CALL NO. 206  
CONTRACT ID NO. 121354  
ADDENDUM # 2

Subject: Trigg-Marshall Counties, 121GR12D054-BRO  
Letting November 16, 2012

- (1) Revised - Plan Sheets - R1, R2A, R2B, R7, R8, R13, R14, R31, R32, R33, R35, R36, R38, R40, R41, R83, R85, X14, X15, X16, X18, X20, X21, & X26
- (2) Deleted - Plan Sheets - R25, R26, & R86 through R90
- (3) Revised - Front Page of Proposal
- (4) Revised - Completion Date - Page 4 of 177
- (5) Added - Dynamic Pile Testing - Pages 78(a)-78(c) of 177
- (6) Added - Static & Pseudo-Static Pile Testing - Page 96(a) of 177
- (7) Revised - Material Summary - Pages 130-132(a) of 177
- (8) Revised - Bid Items - Pages 173-175 of 177

BRO 0801 (093)  
RECONSTRUCT US 68 / KY 80  
GRADE & DRAIN PLANS

LAGOON BRIDGE  
END BENT 2 GROUND MODIFICATION

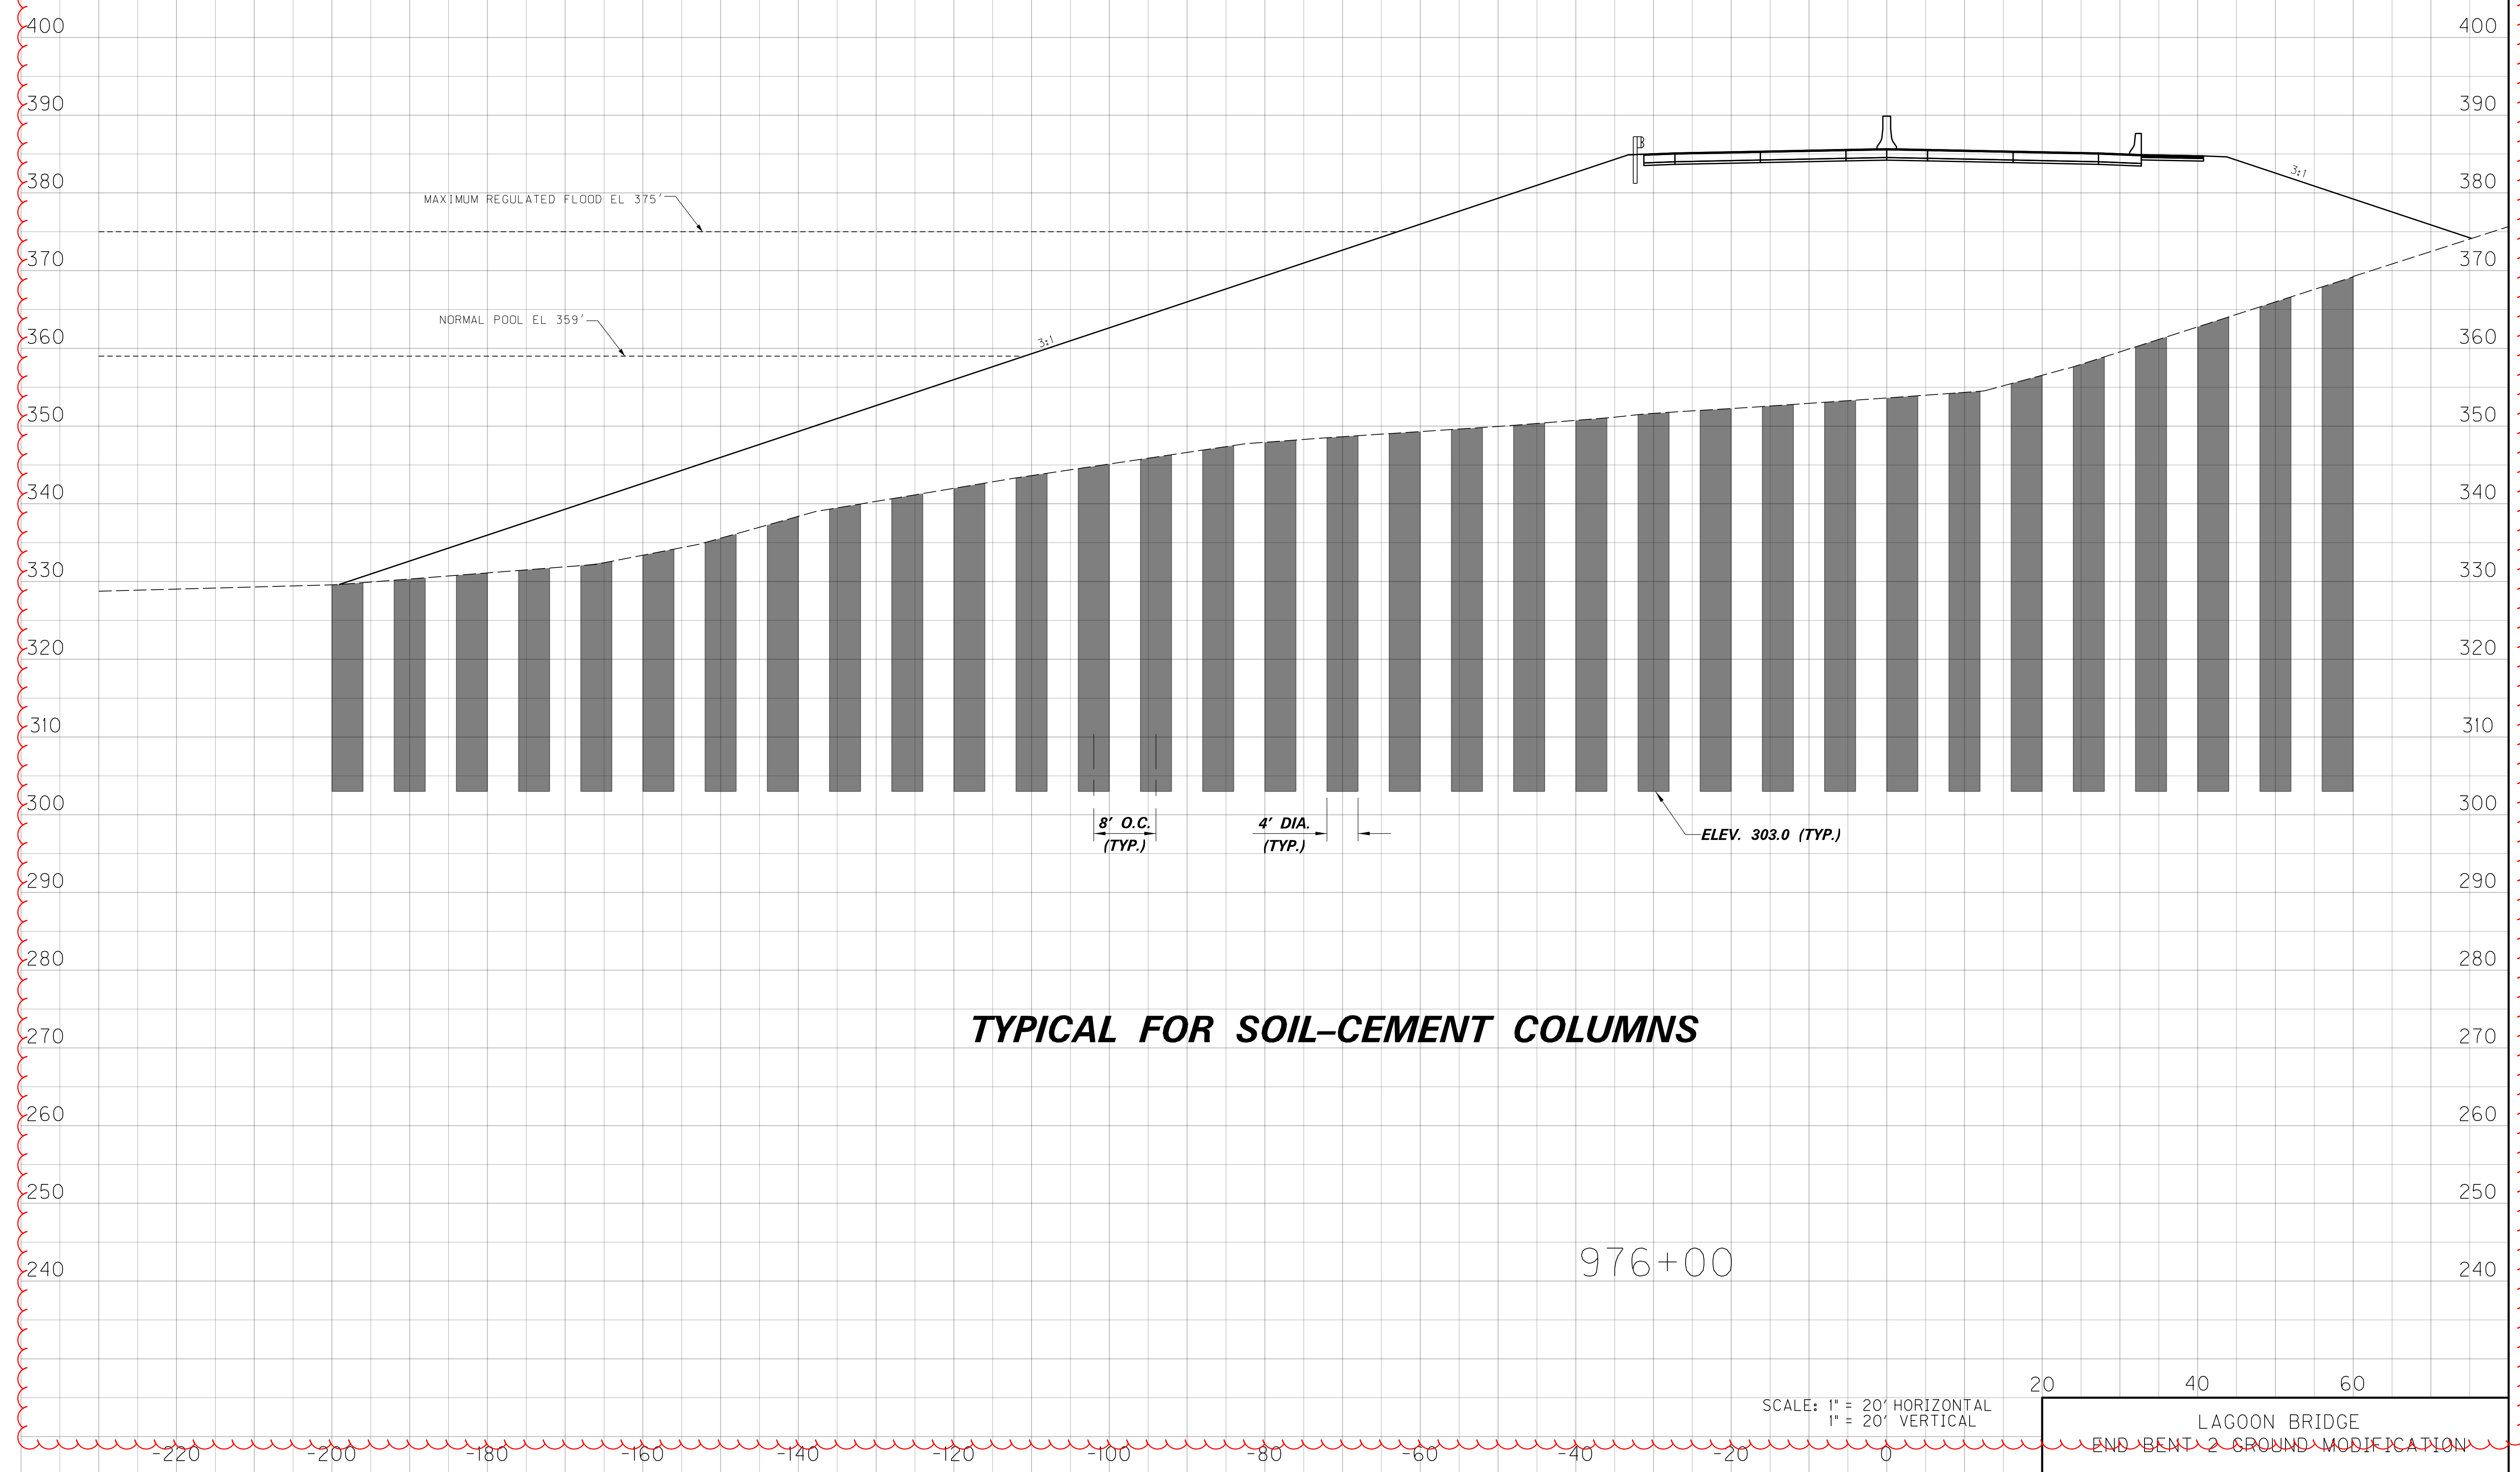
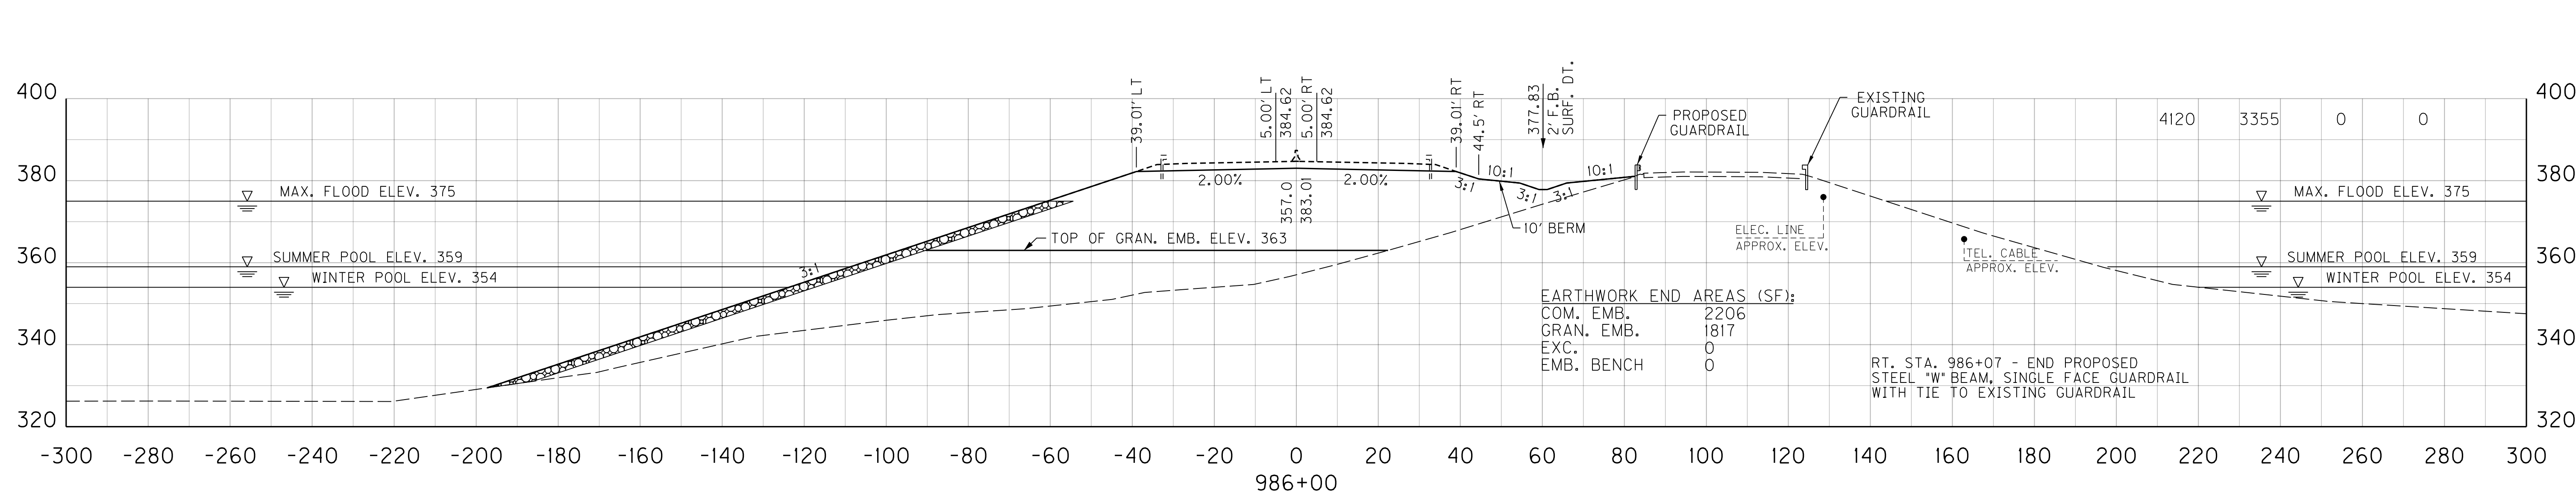
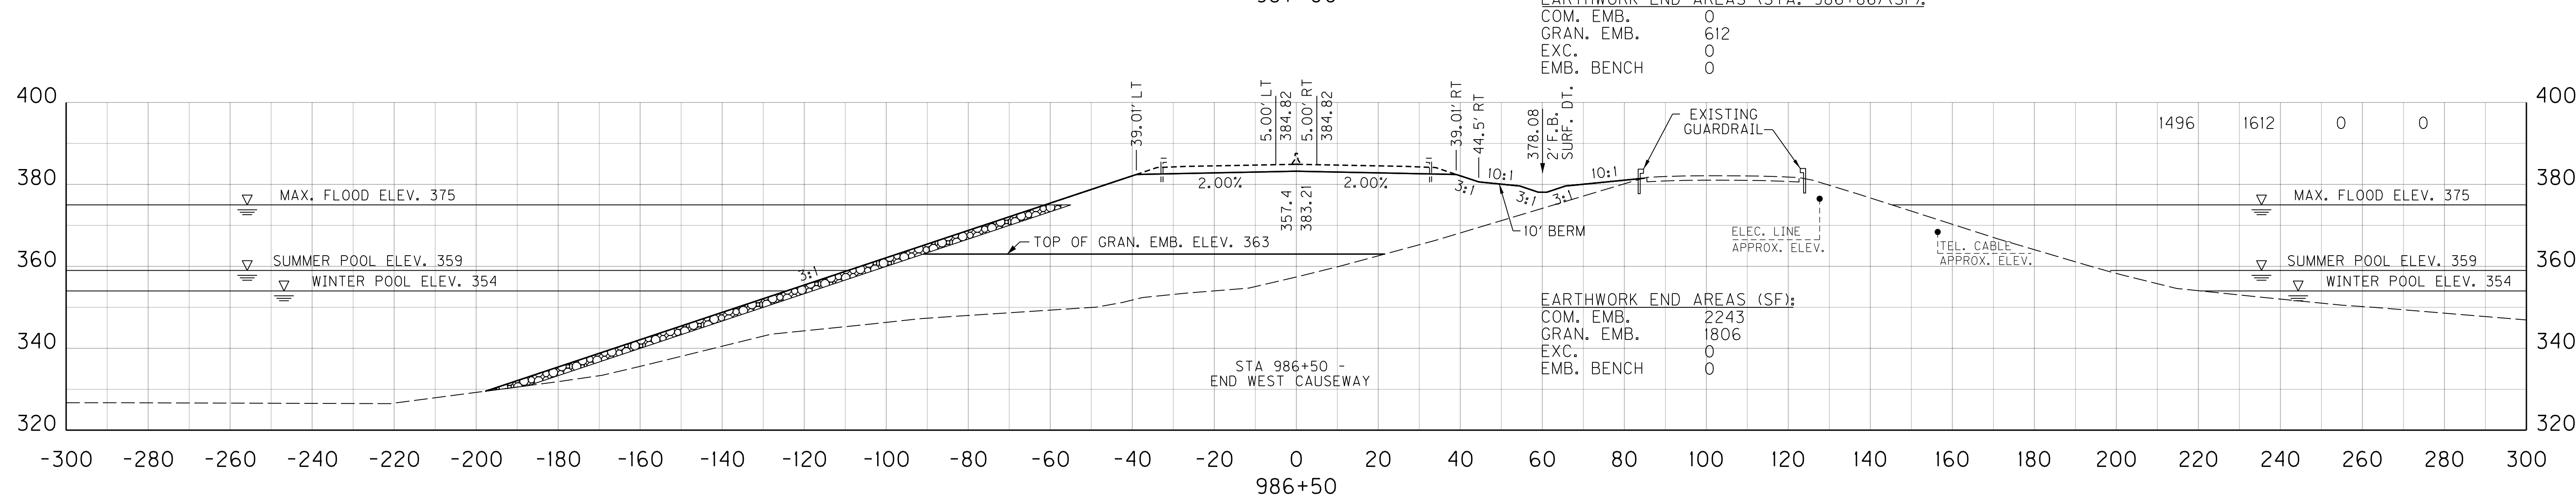
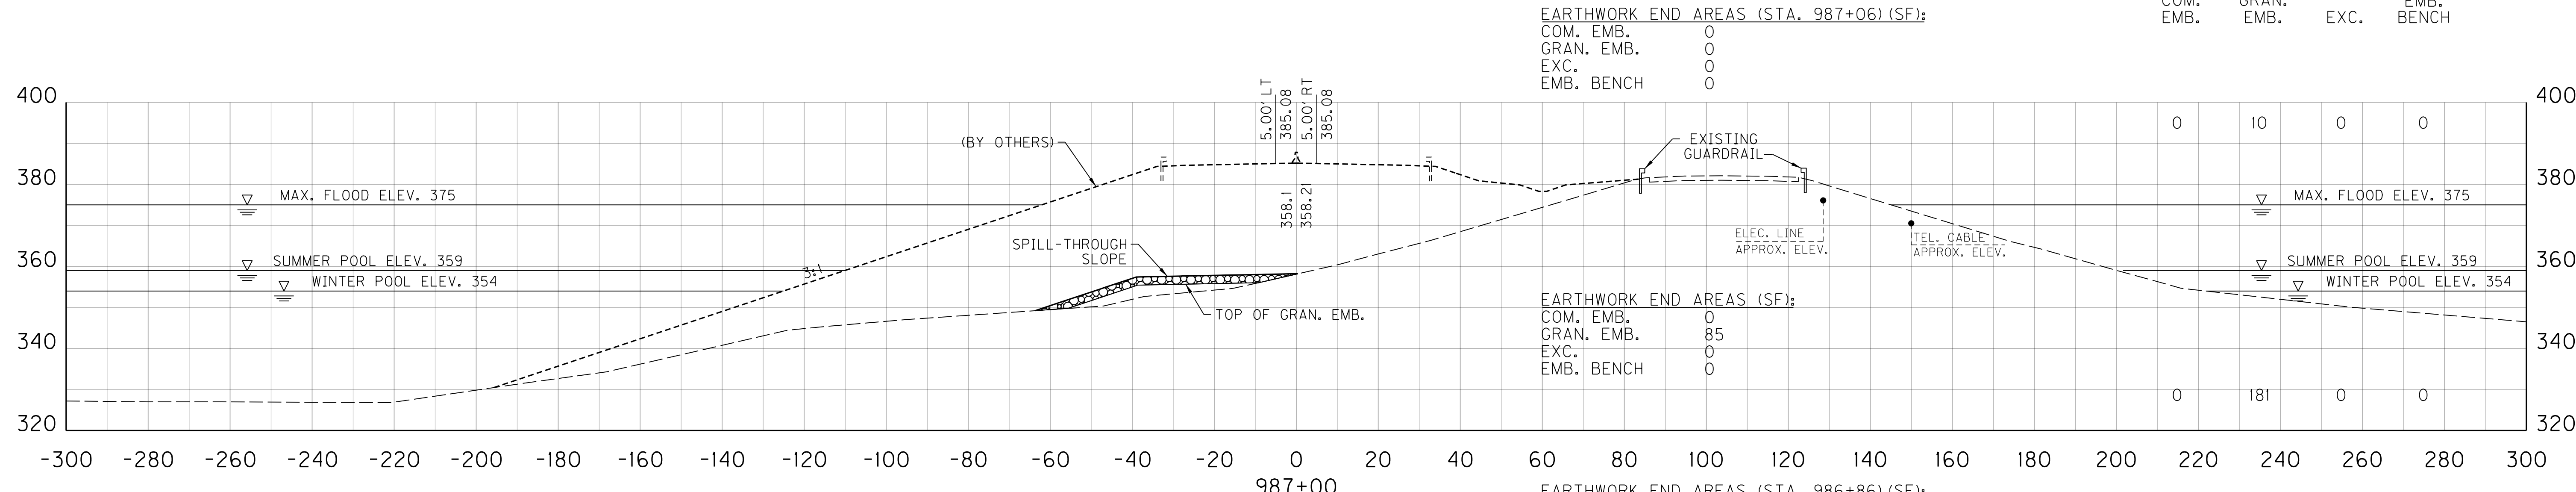
△ REVISED 10-31-12

COUNTY OF	ITEM NO.	SHEET NO.
MARSHALL/TRIGG	1-180.75	X16

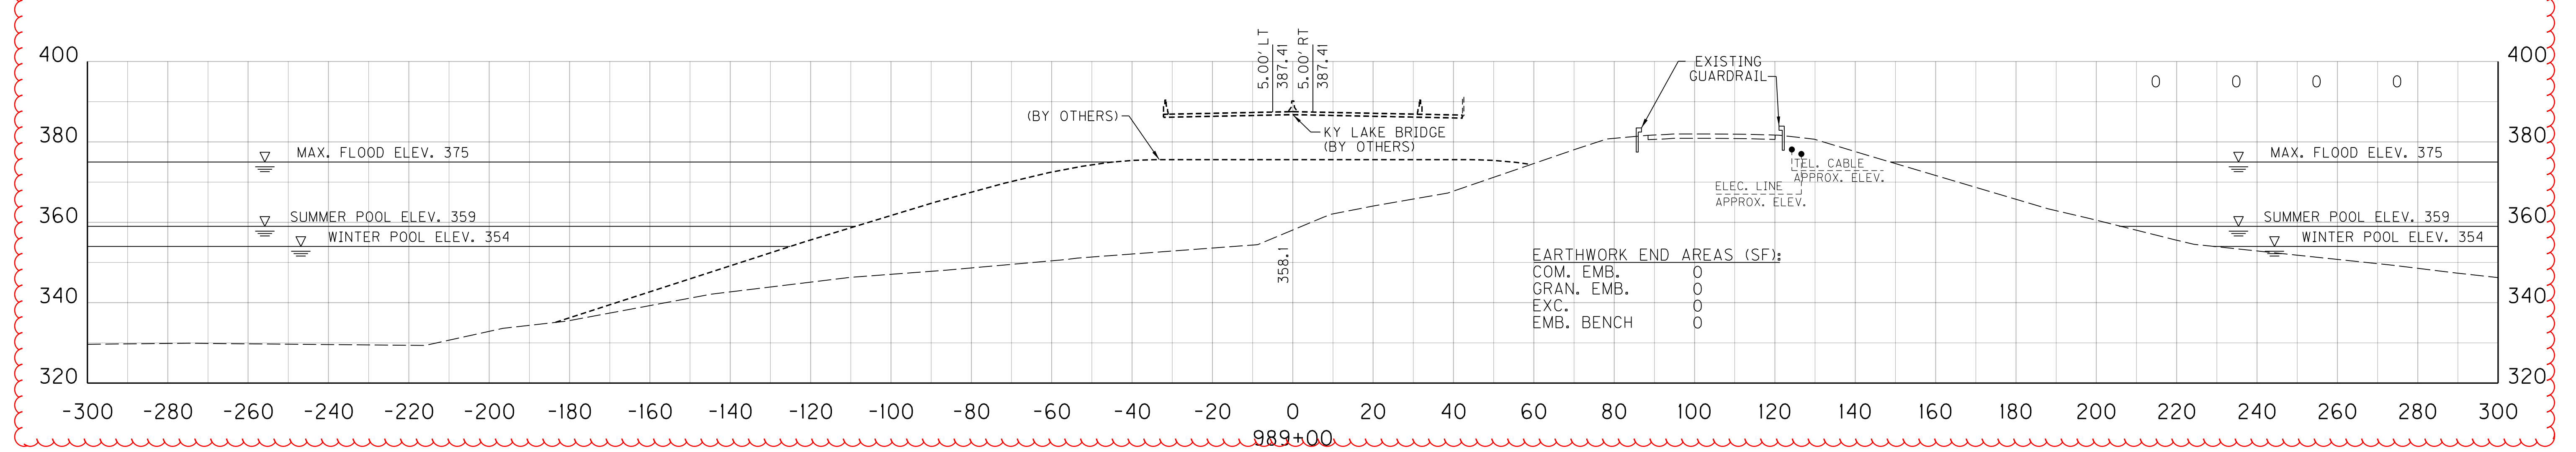
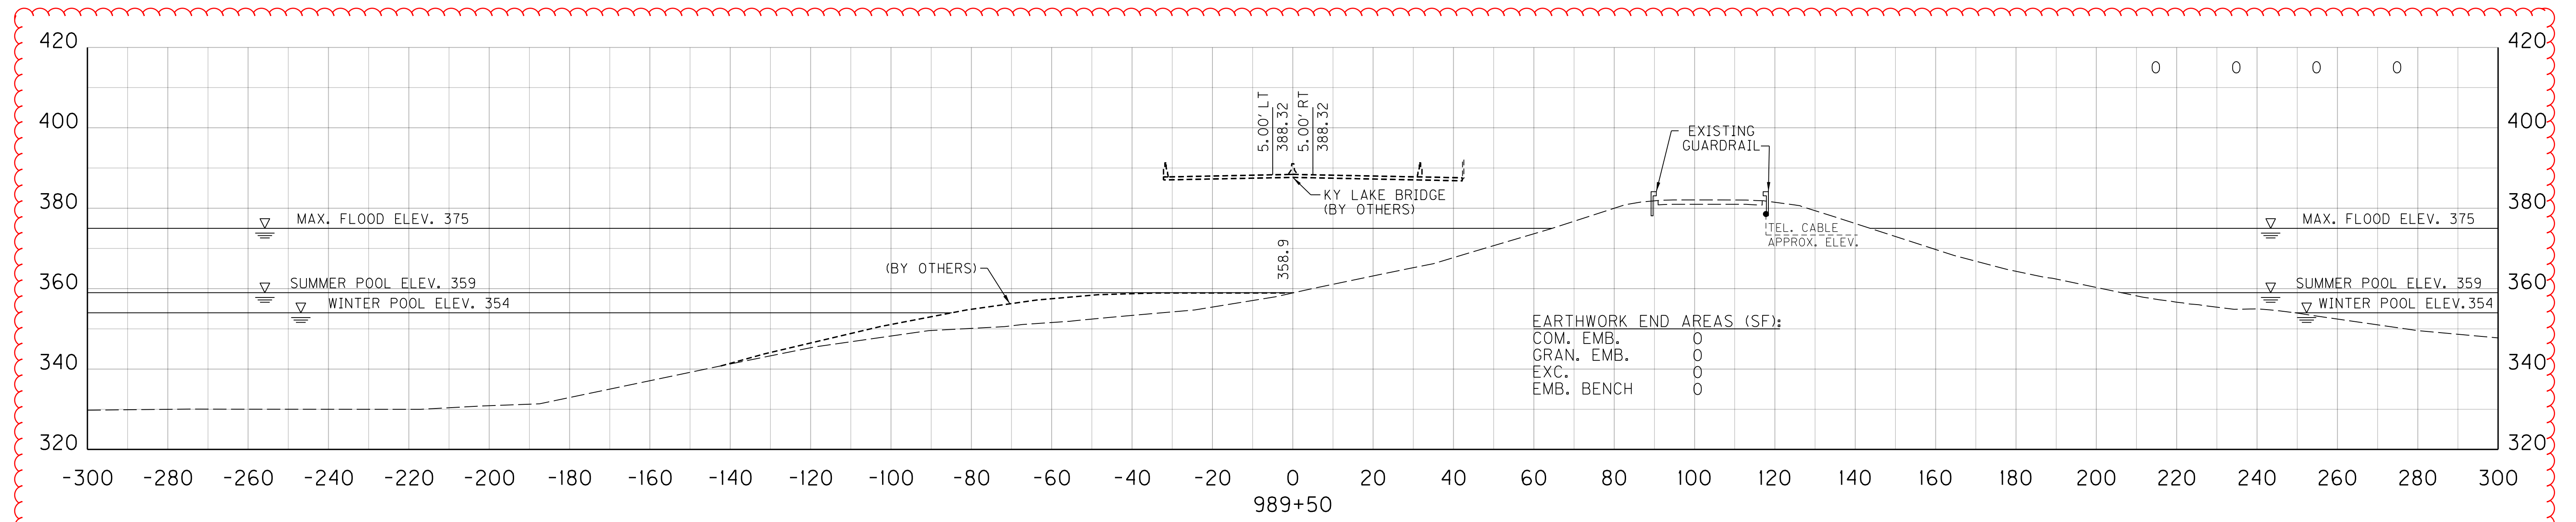
△ REVISED 10-31-12
